Olsson
1027 S. Main Street,
Suite 503
Joplin, MO 64801
February 12, 2024

ADDENDUM NO. 3
Glendale Parallel Interceptor Improvements – Lower Reach
Joplin, MO – 2024
Bid Date/Time: February 21, 2024 at 10:00 AM
Olsson Project No. C17-0643

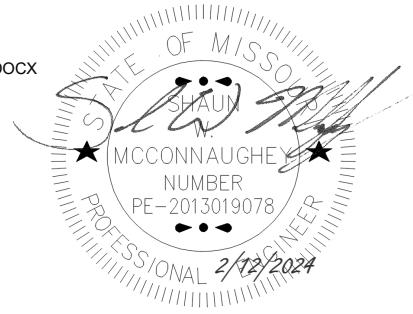
1. Flow Monitoring Equipment (Southeast Diversion Structure)
   a. ~~Contractor to provide a sluice gate matching the attached submittal for the proposed 21" dia. Pipe.~~
   b. *Proposed 21" Pipe at downstream end of structure may be reduced to the existing 18" pipe to avoid replacement of the existing sluice gate and flow trough.*
   c. Contractor to provide revised spring ring and/or scissor ring for the installed velocity sensors.
   d. Work shall include installation into the new pipe/ structure and relocation of equipment found during construction.
   e. *Upstream pipe to be connected through the existing structure wall and flow trough may require a grout transition.*
